WESLEY AND MARCUS TILLMAN SUBDIVISION

APPLICATION NUMBER 2 DATE January 18, 2007
APPLICANT Wesley and Marcus Tillman Subdivision
REQUEST Subdivision

WESLEY AND MARCUS TILLMAN SUBDIVISION

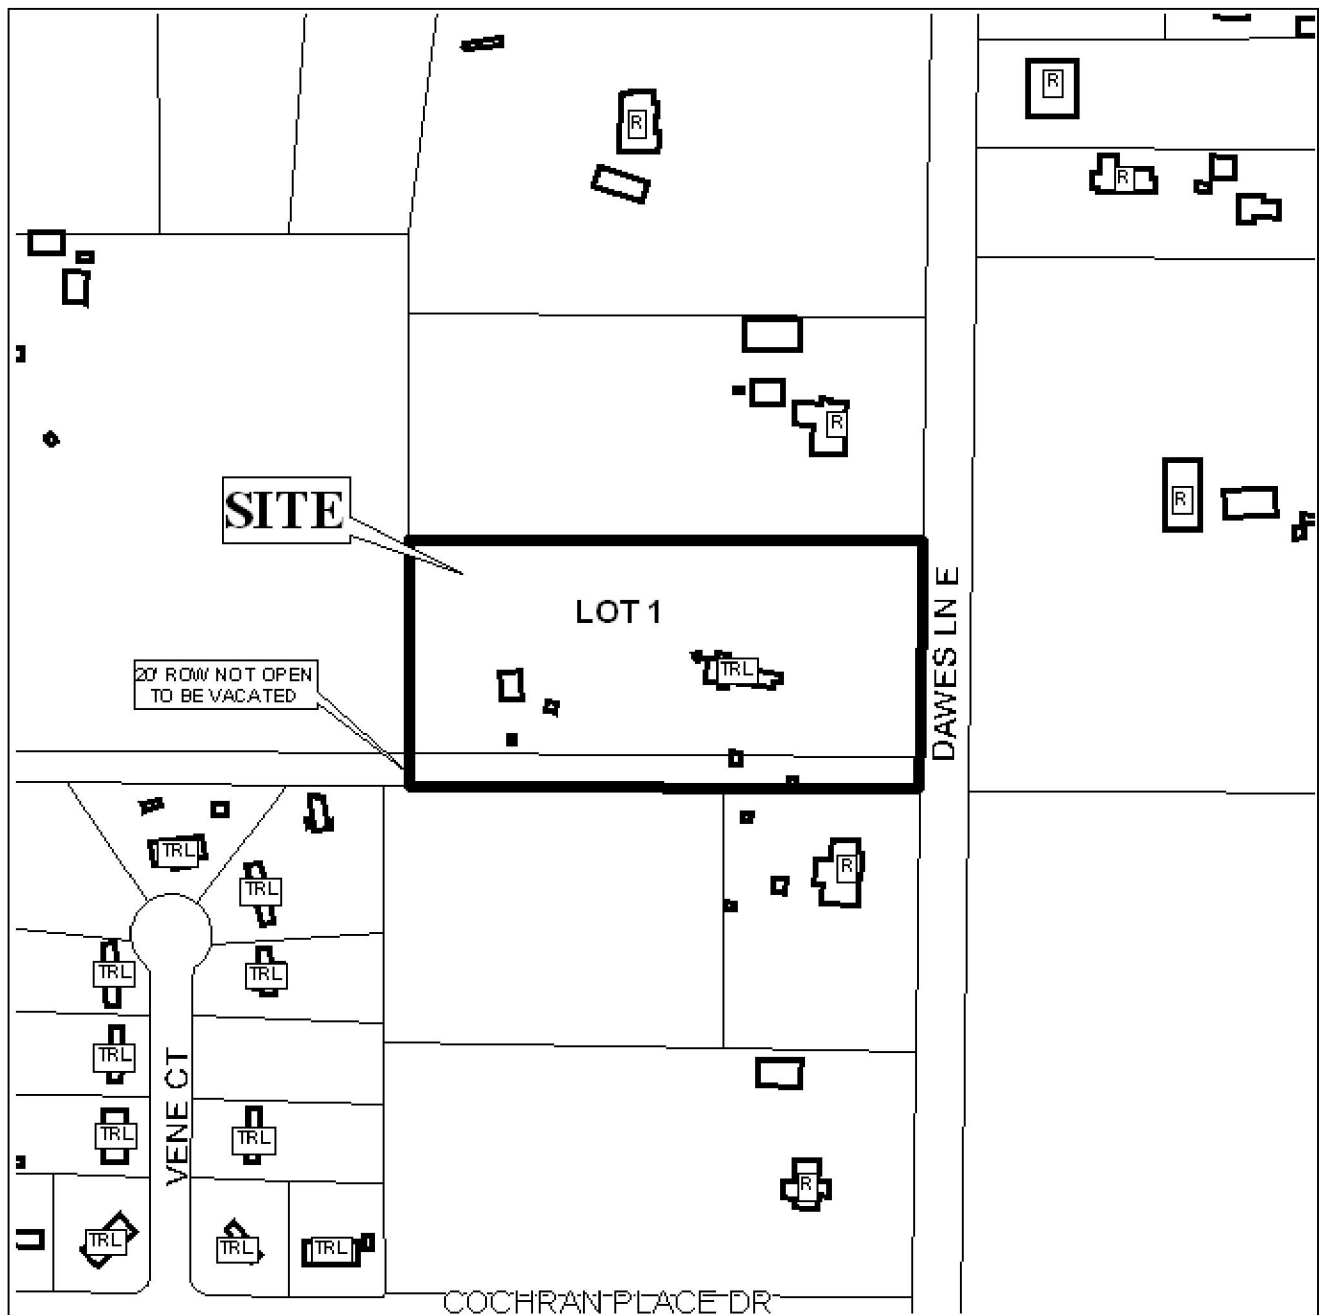
The plat illustrates the proposed 1 lot, $3.0 \pm$ acre subdivision which is located on the West side of Dawes Lane East, $698' \pm$ North of Cochran Place Drive. The applicant states that the subdivision is served by public water and individual septic systems. It should be pointed out that it appears that the site is actually $4.4 \pm$ acres, based upon staff calculations.

The site fronts onto Dawes Lane East, a minor street with adequate right-of-way, and South Roadway East, an unopened right-of-way that is 40-feet in width. While Dawes Lane East is a minor street, access management is a concern. It is recommended that the lot be limited to two curb-cuts, with the size, design and location to be approved by the Mobile County Engineering Department.

Finally, there are errors in the written legal description, and it does not appear to include the right-of-way to be vacated.

With the vacation of South Roadway East right-of-way, the plat is recommended for Tentative Approval, subject to the following conditions: 1) completion of the right-of-way vacation process prior to recording the final plat; 2) placement of a note on the final plat stating that the lot is limited to two curb-cuts onto Dawes Lane East, with the size, design and location of all curb-cuts to be approved by the Mobile County Engineering Department; 3) placement of a note on the plat stating that a letter from a licensed engineer certifying compliance with the City of Mobile's stormwater and flood control ordinances must be provided to the Mobile County Engineering Department and the Planning Section of Urban Development prior to the issuance of permits; 4) labeling of each lot with its size in square feet, or provision of a table on the plat with the same information; 5) correction of the errors in the legal description, and inclusion of the right-of-way to be vacated in the description; and 6) placement of a note on the Final Plat stating that any lots which are developed commercially and adjoin residentially developed property must provide a buffer, in compliance with Section V.A.7. of the Subdivision Regulations.
